UNITED STATES PATENT AND TRADEMARK OFFICE

APPLICATION NO.	FILING DATE	FIRST NAMED INVENTOR	ATTORNEY DOCKET NO.	CONFIRMATION NO.
09/746,990	12/22/2000	Su-Syin S. Wu	JOHNA.37C1CP1	8376
20995	7590	11/17/2004	EXAMINER	
KNOBBE MARTENS OLSON & BEAR LLP 2040 MAIN STREET FOURTEENTH FLOOR IRVINE, CA 92614			MCKANE, ELIZABETH L	
			ART UNIT	PAPER NUMBER
			1744

Office Action Summary

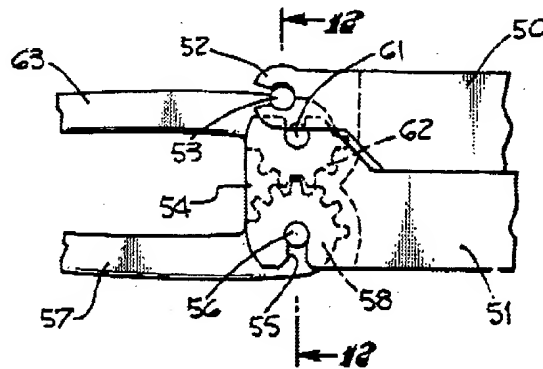
4. Claims 1, 4, 6, and 21, 23-25 are rejected under 35 U.S.C. 102(b) as being anticipated by Markham (U.S. Patent No. 5,176,699).

Markham teaches a medical device (forceps) comprising a first part **57** and second part **63** rotatable with respect to one another about a pivot **54** and having a contact area

58,62 therebetween. The contact area comprises a plurality of straight, parallel, grooved projections (e.g. gears) on both the first and second part.

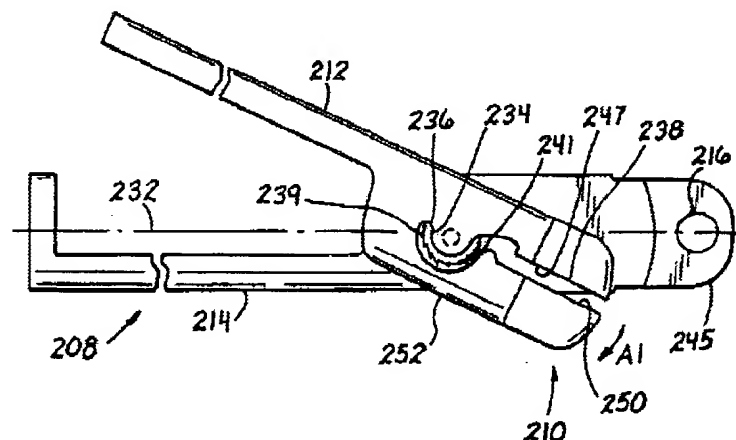
5. Claims 1, 4, 6, 22-25 are rejected under 35 U.S.C. 102(b) as being anticipated by Sackier et al (U.S. Patent No. 5,776,146).

Sackier et al discloses a medical device (surgical clamp/holder) having a first part 214 and a second part 212 rotatable with respect to one another about a pivot and having a contact area therebetween at the pivot, wherein the contact area comprises a plurality of straight, parallel, grooved projections at 239.
